SUBJECT: NORTH ANNA POWER STATION, UNITS 1 AND 2 RE: INSERVICE TESTING PROGRAM FOR PUMP AND VALVES, THIRD TEN YEAR INTERVAL UPDATE (TAC NOS. MB2221 AND MB2222)

SAFETY EVALUATION BY THE OFFICE OF NUCLEAR REACTOR REGULATION  
RELATED TO THE THIRD 10-YEAR INTERVAL INSERVICE TESTING PROGRAM

NORTH ANNA POWER STATION, UNITS 1 AND 2

Figure No. P-6.1

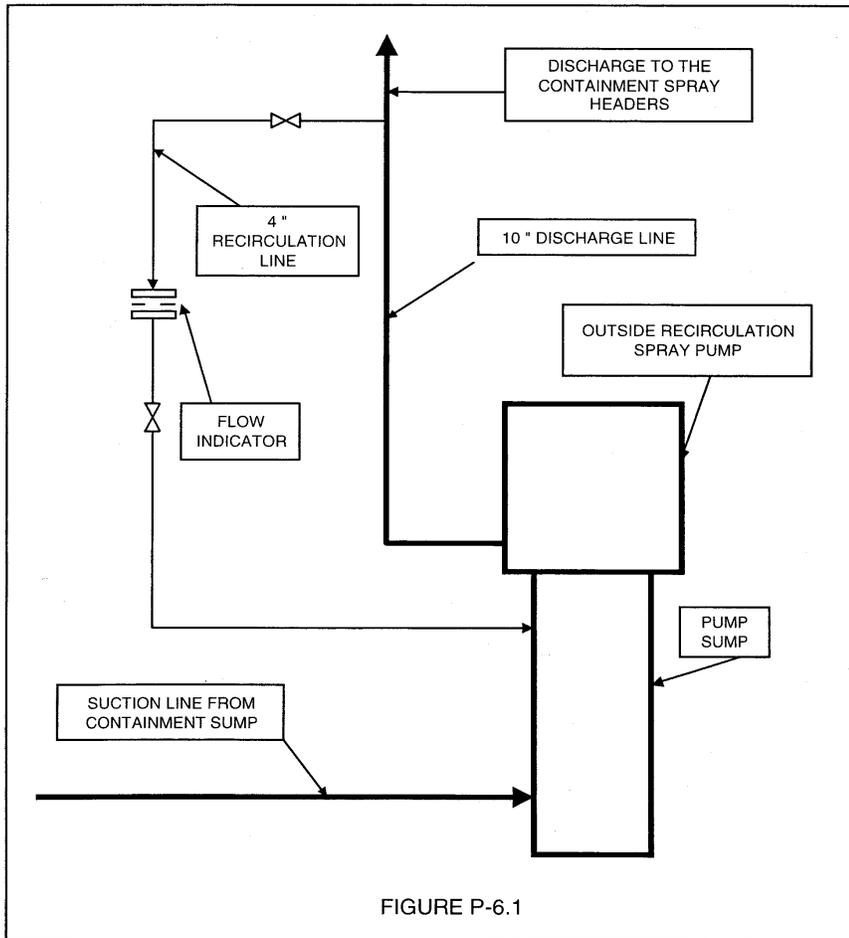
The test loop for the outside recirculation pumps consists of a 10" pump discharge line feeding into a 4" recirculation line which feeds back to the pump sump. Refer to Figure P-6.1. With test loop, pump design flow cannot be established. Also, the discharge piping was not designed to be temporarily reconfigured so that pump design flow could be achieved.

As an alternative to flow testing at the design flow rate, the test loop shown in Figure P-6.1 will be used. Reference flows are typically established with test loop in the range of 1450 to 1500 gpm, whereas the pump design flow is 3640 gpm. The low reference flows result from restrictions due to the small 4" recirculation line and the limited volume of water in the test loop. The limited water volume results in a rapid temperature rise in the test loop due to heat loads added by the running pump. This temperature rise affects repeatability of the measured hydraulic parameters. Therefore, care must be taken to ensure that the pump run time is limited and that the flow rate is maintained within an optimal range.

As an alternative to the flow testing at design flow rate, the licensee has proposed testing with a test loop shown in Figure P-6.1. The test loop is a 4-inch recirculation line. The reference flows established with this test loop are in the range of 1450 to 1500 gpm whereas the pump design flow is 3640 gpm. The low reference flows are limited due to size of 4-inch recirculation line. The limited water volume and the heat loads added by the running pump will rapidly raise the temperature of the water in the test loop. The testing will be performed in a manner to ensure that the pump run time is limited and the flow is maintained within an optimal range. The highest flow that can be measured while maintaining stable test conditions is approximately 40 percent of design flow. Measuring more than one point on the pump curve is limited to flow rates less than the 1450 to 1500 gpm range. Throttling the flow down to 20 percent of design flow to measure another point on the curve may cause flashing across the throttle valve producing hydraulic instabilities and less-than-meaningful results. In the 1450 to 1500 gpm range of the head curve for these pumps, the head curve is not flat but well sloped. (See Figure P-6.2 for Units 1 and 2). As shown in the Figure P-6.2, the test point falls on the nominal vendor curve. Any deviation from the nominal curve will show degradation of the pump.

gure No. P-6.2 (UNIT-1)

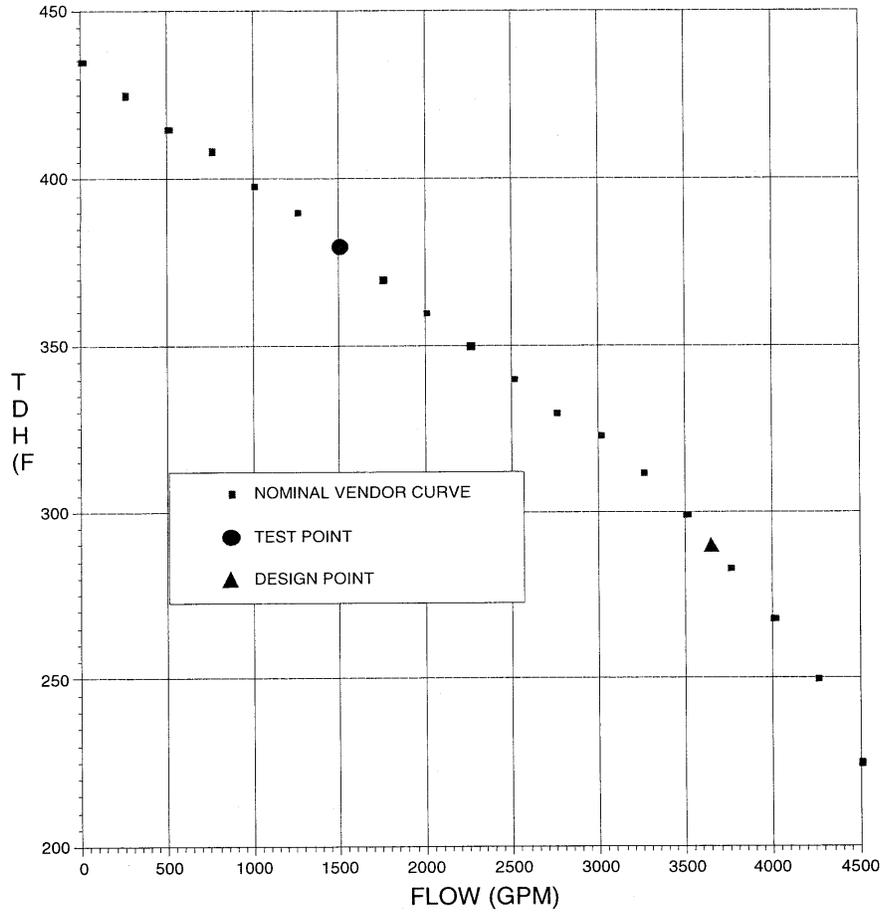
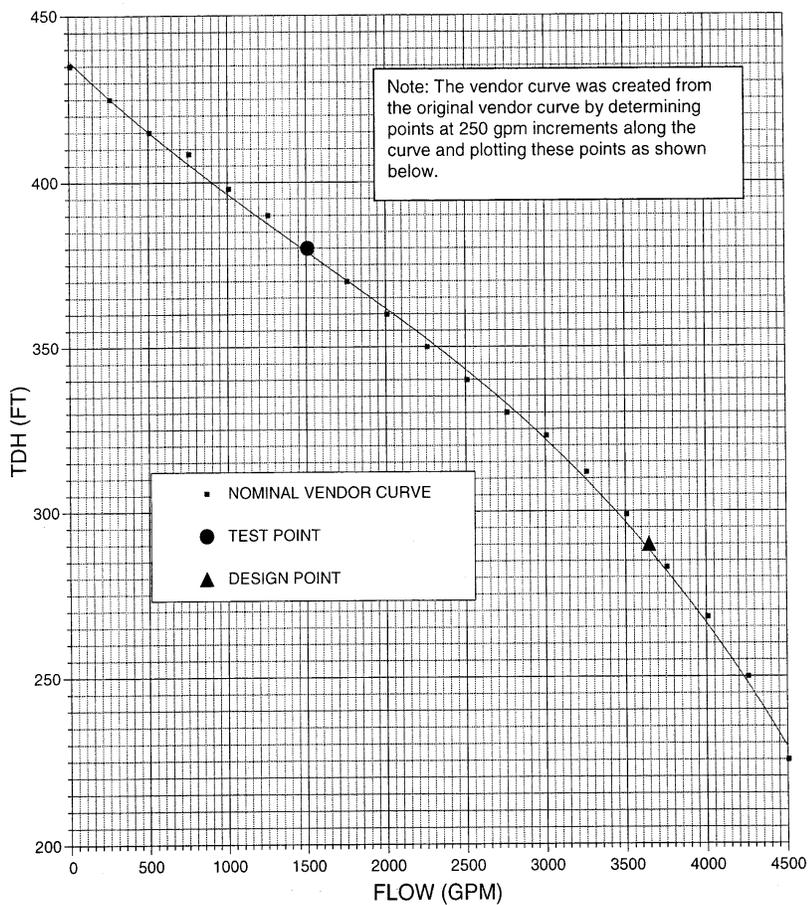
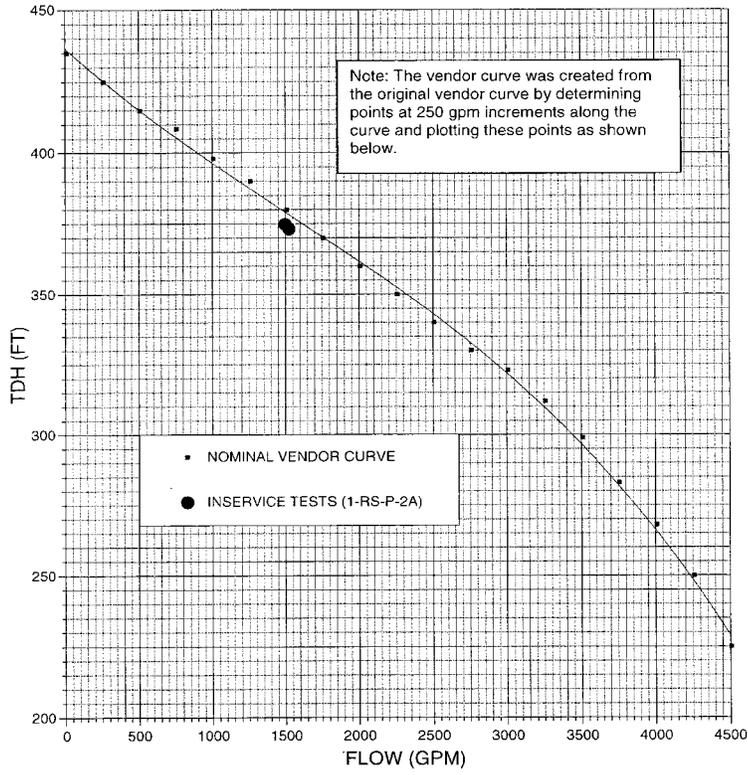
In the 1450 to 1500 gpm range of the head curve for these pumps, the head curve is not flat, but well sloped. Refer to Figure P-6.2. Therefore, as performance degrades due to internal recirculation caused by increasing internal pump clearances, the differential pressure will measurably decrease for a given reference flow rate. As discussed above, testing the outside recirculation spray pumps over the full range of the pump curve and measuring at least five points along the curve is impractical.

As an alternative to testing within 20% of the design flow, the reference values will be established at approximately 40% of the design flow. It is our understanding that testing at design flow is important for pumps with characteristic head-flow curves that are flat or gently sloping in the low flow region (little change in developed head with increasing flow). In the low flow region, increasing internal flows, usually due to wear, are difficult if not possible to detect. Pumps with the "flat" curves at low flows should be tested at near design conditions to determine if increasing internal recirculation flows have degraded pump performance to the point where design requirements cannot be met. This situation does not apply to the outside recirculation pumps if they are tested at 40% of design flow. Testing at the reference flows will detect pump degradation because the pump curve is well sloped at the point of testing. Refer to Figure P-6.2. [for Units 1 and 2]

From Figure P-6.2, the nominal vendor curves, the shutoff head of pumps is 435 feet. As discussed above, the pump can only be tested on a recirculation flow path which is sized for approximately 40 percent (1500 gpm) of the design flow of 3640 gpm. In case of Seabrook Station, Unit 1 (Reference 5), the shutoff head is 700 ft. The pump can be tested on recirculation flow path which is sized for approximately 68 percent (1900 gpm) of the required design flow of 2808 gpm. The flow and TDH values from the head-flow curves for North Anna Station and Seabrook Station (Reference 5) are shown in the following table for comparisons:

The licensee provided curves (Figure P-6.2 ) showing flow rate versus the corresponding TDH. The intent of the curve is to provide trend data on the TDH at each measured flow rate for the outside recirculation pumps. The expected result is that at higher flow rates, there is a lower pump TDH. This provides an indication that the pumps were tested in an area of the curve where the intent of the comprehensive test would be satisfied.

Figure No. P-6.3

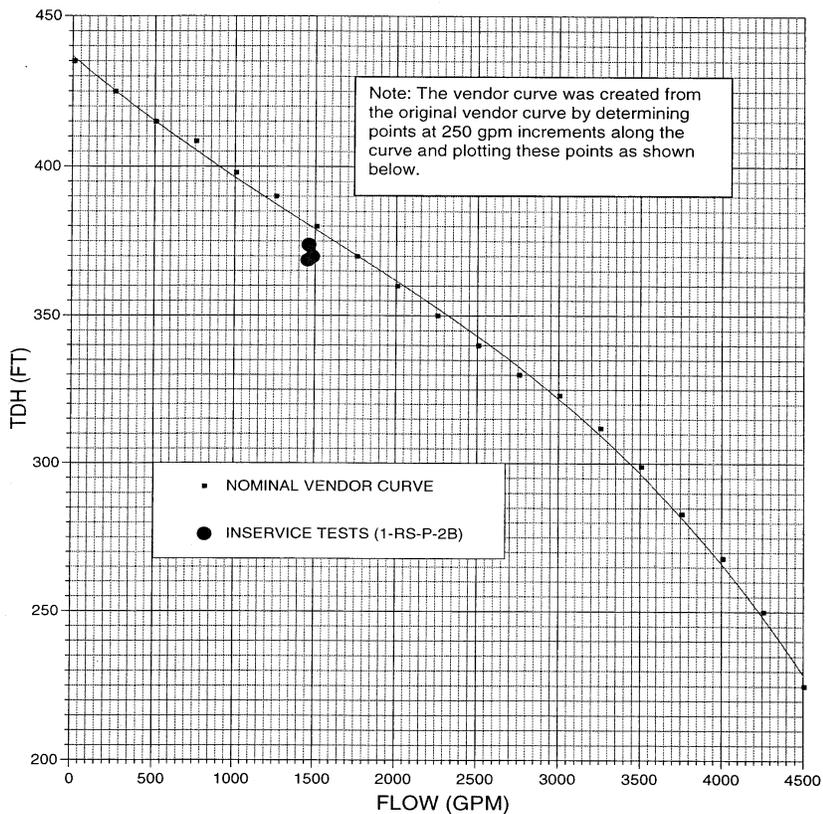
The licensee provided pump curves for Units 1 and 2. Figures P-6.3 and P-6.4 are for Unit 1 outside recirculating spray pumps 1-RS-P-2A and 2B. The curves in these figures show nominal vendor curves with inservice test points. For Unit 2 pumps 2-RS-P-2A and B, the curves in Figures P-6.5 and P-6.6 show not only inservice test points but preservice test points. The reason is that the licensee performed preservice tests for Unit 2 pumps only due to hardship as explained by the licensee in the Section 3.6.2 above. The Unit 2 pump curves shows that the slopes of the nominal vendor curves and the preservice test are very close. The slopes of the Unit 1 pump pretest curves would presumably have resembled the slopes of the Unit 2 pump preservice tests, because the Units 1 and 2 pumps are similar. Therefore,
